# CTfastrak

## ROAD SAFETY AUDIT

New Britain, West Hartford, and  
Hartford

**AUGUST 2025**

Exhibit 49: Downtown New Britain Station Recommendations

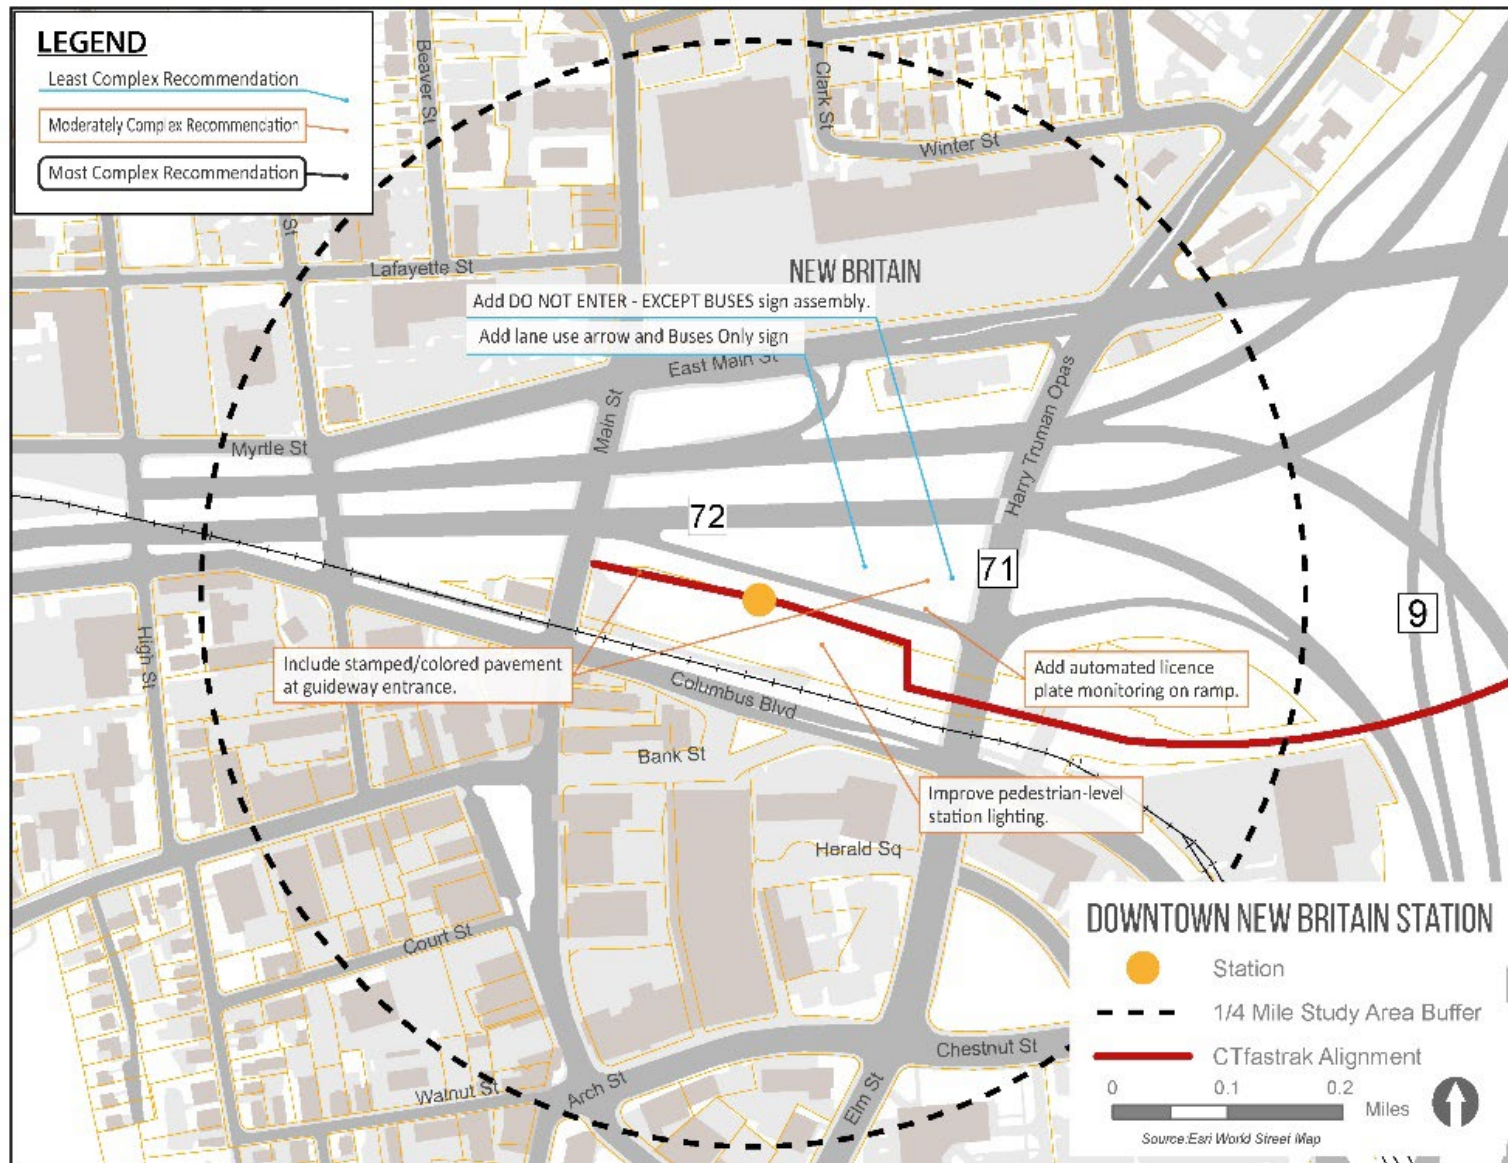
- CTfastrak representatives said that a safety and security concern at this location is that unauthorized drivers (general public) mistakenly take the CTfastrak bus only ramp into the CTfastrak Downtown New Britain Station when exiting Route 72 eastbound at Exit 1C. Properly navigating the exit is confusing to motorists, especially when trying to take a right at the end of Exit 1C onto Route 71 into Downtown New Britain. Some drivers end up incorrectly taking the first right ahead of the intersection onto the ramp into Downtown New Britain Station instead of taking the proper right at the traffic light. Many of the unauthorized drivers who end up in Downtown New Britain Station say they are on their way to the courthouse in New Britain.

- An estimated 180 – 200 unauthorized drivers from the general public are documented each month mistakenly entering the CTfastrak Downtown New Britain station. Most of these motorists are entering from the ramp off Route 72 eastbound at Exit 1C, however, some unauthorized motorists also enter the station from Main Street. Exhibit 26 and Exhibit 27 show the bus-only entrances into Downtown New Britain Station from Main Street and Route 72 eastbound at Exit 1C.

- According to bus operators, lighting in the station area is a concern. Lamp heads are too short to adequately distribute light onto the entire area. Pedestrians crossing the interior station area roadway between the bus bays are difficult for the operators to see at night. Additionally, security on-site is challenging because of the poor lighting. Station area lighting is shown in Exhibit 28.

- Mid-block crossings within the station are an issue. Many people will not walk the several bays to get to the existing crossing that is shown in Exhibit 29. A new at-grade railroad crossing for pedestrians will be installed south of the station soon. This could add additional demand for mid-block crossings within Downtown New Britain Station.

- 1) Install Do Not Enter – Except Buses sign assembly in the gore in the vicinity of the first chevron sign.
  - **Next Step:** Contact CTDOT Maintenance
- 2) Add an existing lane use arrow (left-through-right) at the beginning of the bus only ramp to indicate that right-turning traffic does not need to use the bus ramp. Add additional BUS ONLY pavement markings, and/or additional paint to more clearly distinguish the CT *fastrak* Downtown New Britain Station ramp is only for buses and not cars.

- 1) Install colored pavement at guideway entrance.
  - **Next Step:** CTfastrak Improvement Project
- 2) Improve pedestrian-level lighting within the station area.
  - **Next Step:** Contact CTDOT Maintenance
- 3) Install camera detection equipment, license plate reader, and video message sign at bottom of ramp into Downtown New Britain Station to automatically detect and inventory whether vehicle is authorized or not to enter the station and to instruct unauthorized vehicles how to leave the station. This ensures 100 % of the vehicles entering the station from the off-ramp are identified. This can allow the security guard to do other tasks while on duty.
  - **Next Step:** Contact CTDOT Maintenance and HNS (CTtransit)

Exhibit 50: Stanley Street Crossing Recommendations

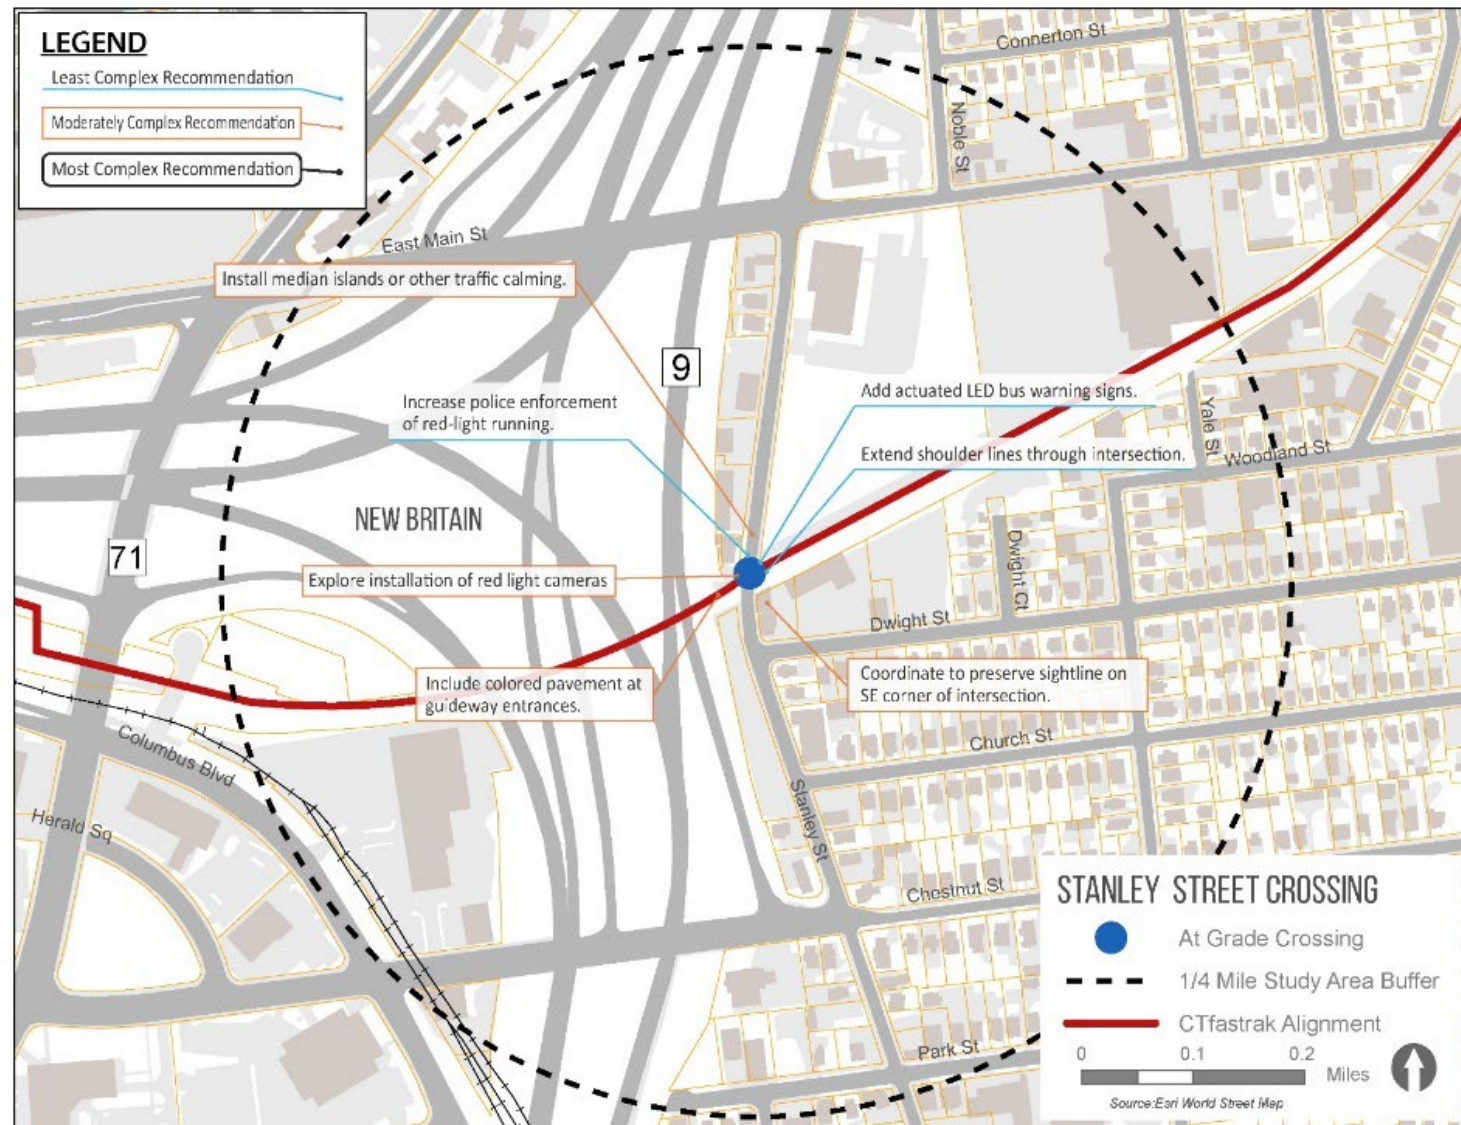
- CTfastrak operators have complained that there is insufficient overhead lighting at this location.
- Unauthorized access onto the CTfastrak fixed guideway is common at this crossing. A motorist illegally entered the guideway here during the RSA field audit. The motorist turned around as soon as the team conducting the field audit (all wearing bright retro-reflective vests) stopped them and instructed them to turn around.
- Prior to the RSA field audit there was an abandoned building located on the southeast corner of this intersection, which was demolished by the City of New Britain in fall of 2023. The building was located close to the roadway and decreased sight lines at this

- Crosswalks are only present on three legs of the intersection despite the fact there are sidewalks at and approaching all four corners of the intersection. Not having crosswalks on all legs of the intersection may encourage unsafe crossings, including unsafe mid-block crossings along Stanley Street between that intersection and the next.

- There are no pedestrian signal heads or accessible pedestrian signals (APS) at this location. Since there are no pedestrian signal heads, it is not clear that pedestrians cannot cross the guideway when the light is green.

- Motorists were observed running the red light at this location during the RSA field visit.

- 1) Extend shoulder lines through the intersection.
  - **Next Step:** Contact CTDOT Maintenance
- 2) Add actuated overhead light emitting diode (LED) bus warning signs at the intersection.
  - **Next Step:** Contact CTDOT Maintenance
- 3) Increase police enforcement of red-light running.
  - **Next Step:** Contact Local Traffic Authority (LTA)

- 1) Coordinate with City to ensure future development on the property at the southeast quadrant of the intersection preserves clear sight line (may require zoning change).
  - **Next Step:** Contact City of New Britain Economic Development Office
- 2) Install median islands or other traffic calming solutions on Stanley Street approaching the crossing.
  - **Next Step:** CTfastrak Improvement Project

- 3) Install colored pavement at guideway entrance.
  - **Next Step:** CTfastrak Improvement Project
- 4) Explore red light cameras to assist with traffic enforcement.
  - **Next Step:** LTA / municipality to consider applying for an [Encroachment Permit](#) through the District permit office

Exhibit 52: Smalley Street Crossing Recommendations

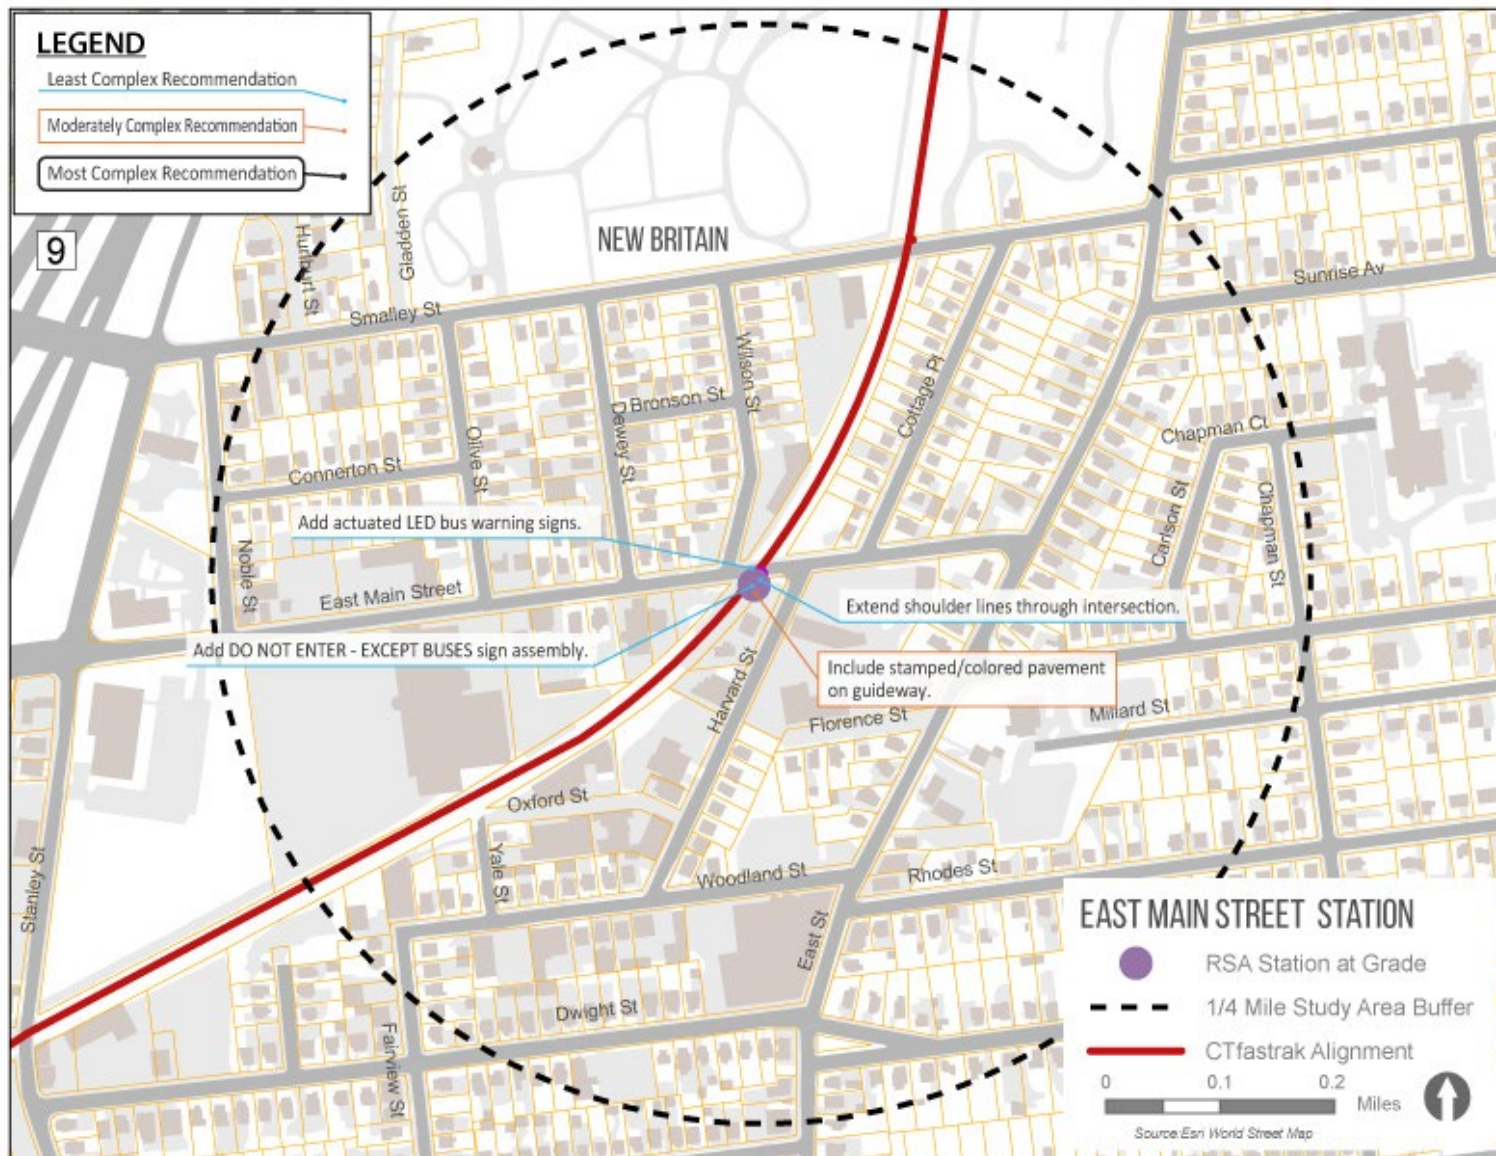
- There are no pedestrian signal heads at this location.
- The pedestrian pushbuttons are not ADA compliant.
- “No Turns” signage may be confusing, as shown in Exhibit 33.
- Unauthorized access onto the CTfastrak guideway is common at this crossing
- The observed signal timing is inefficient. The green light comes on too early and then turns to yellow before the bus can get to the signal. The timing is based on full speed operation.
- Detectors are timed to allow buses to call the green signal before arriving at the intersection, but this is not working correctly due to

- The fence on the southeast side of intersection could limit visibility to eastbound motorists.
- CTfastrak operators have complained that there is insufficient overhead lighting at this location.

- 1) Extend shoulder lines through the intersection.
  - **Next Step:** Contact CTDOT Maintenance
- 2) Add Do Not Enter – Except Buses sign assembly.
  - **Next Step:** Contact CTDOT Maintenance
- 3) Add actuated LED bus warning signs.
  - **Next Step:** CT *fastrak* Improvement Project
- 4) Maintain adjacent shared-use trail year-round.
  - **Next Step:** Coordinate with CT *transit* maintenance

Exhibit 56: Hamilton Street Crossing Recommendations

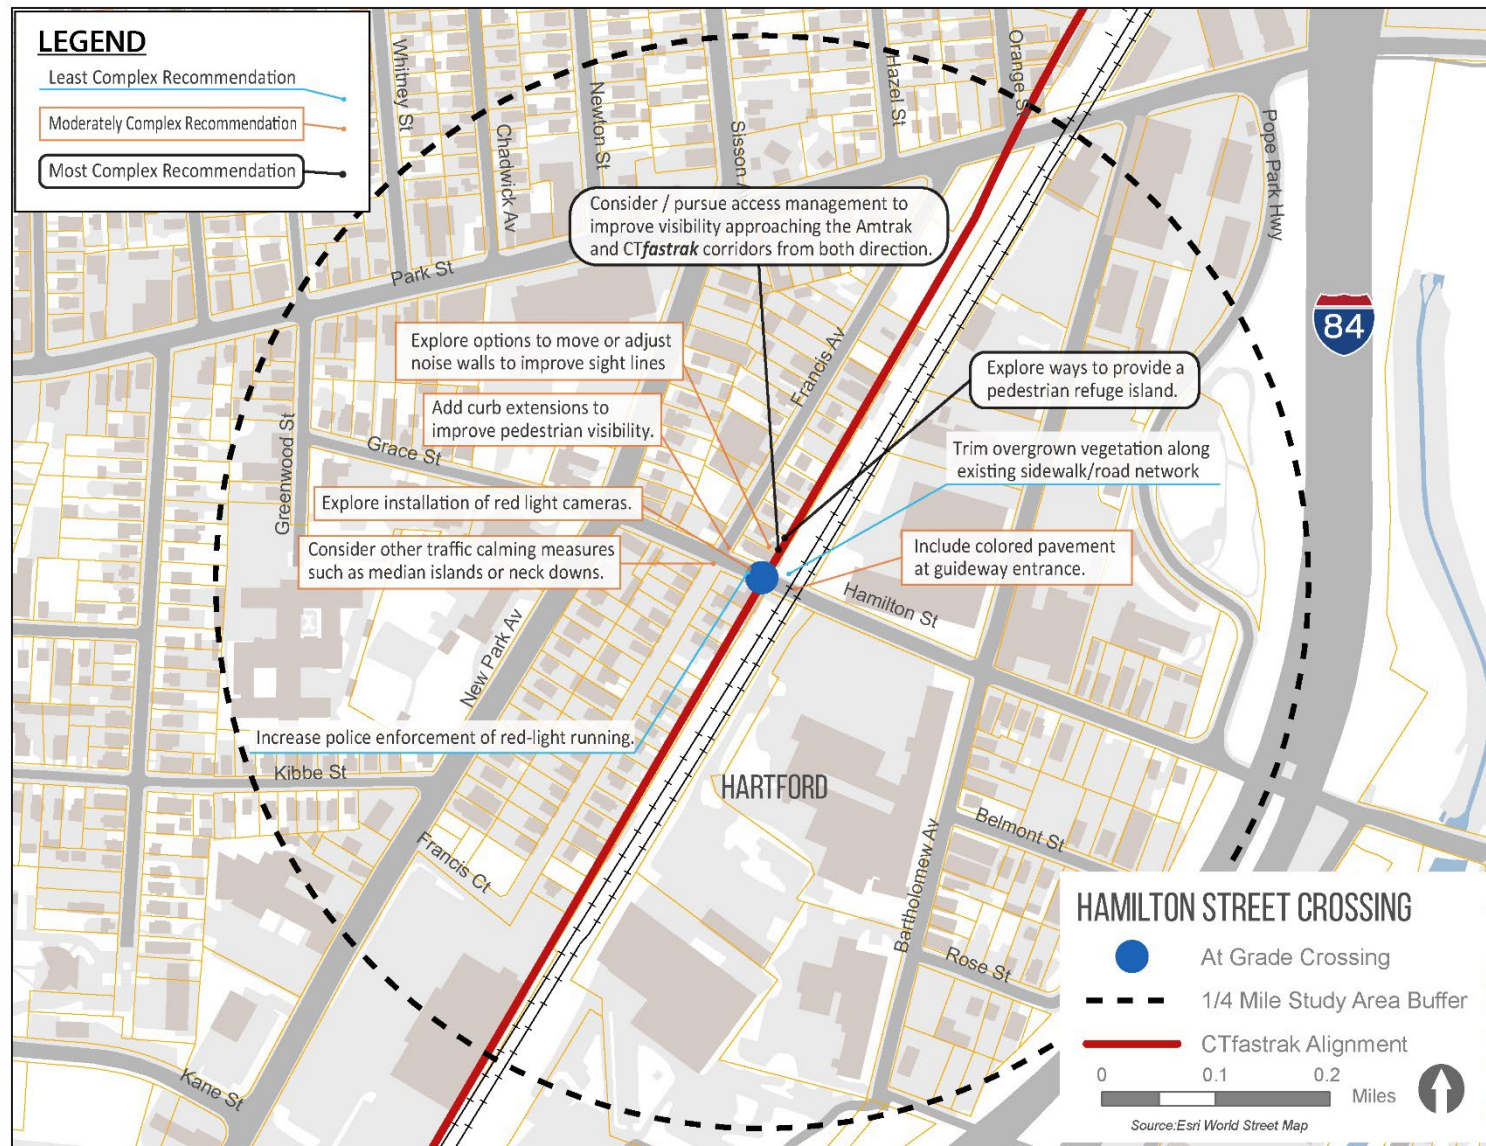
Since CTfastrak service started in 2015, Hamilton Street has the second-highest crash rate of CTfastrak's five at grade intersections. The primary concern is red light running, and the recommendations at this site are largely intended to alleviate this concern. An effective – if expensive – solution is to grade-separate the guideway above this intersection, which would eliminate the issue. Other goals are improving pedestrian accessibility, reducing unauthorized use of the guideway, improving guideway and street operations, and improving bus and railroad safety and operations.

- 1) Increase police enforcement of red-light running.
  - **Next Step:** Contact LTA
- 2) Provide crosswalks across each leg of the intersection of Hamilton Street and Francis Avenue.
  - **Next Step:** Contact LTA
- 3) Trim overgrown vegetation along existing sidewalk / road network.
  - **Next Step:** Municipality to consider applying for an [Encroachment Permit](#) through the District permit office

- **Next Step:** CTfastrak Improvement Project
- 2) Install traffic calming solutions such as median islands or neck-downs on Hamilton Street approaching the crossing.
    - **Next Step:** CTfastrak Improvement Project
  - 3) Add curb extensions to improve pedestrian visibility at street corners.
    - **Next Step:** CTfastrak Improvement Project
  - 4) Explore options to move or adjust noise walls to improve sight lines.
    - **Next Step:** CTfastrak Improvement Project
  - 5) Explore speed and red light cameras to assist with traffic enforcement.
    - **Next Step:** LTA / municipality to consider applying for an [Encroachment Permit](#) through the District permit office

- 1) Explore ways to provide a refuge island (if possible) for safer pedestrian crossings through the intersection across CTfastrak busway and Amtrak rail.
  - **Next Step:** Contact CTtransit and CTDOT Office of Rail
- 3) Consider / pursue access management to improvement visibility approaching the Amtrak and CTfastrak corridors from both directions on Hamilton Street. In particular, there are several large curb cuts / driveways that can be shortened to improve traveler safety.
  - **Next Step:** Coordinate with City of Hartford and property owners.
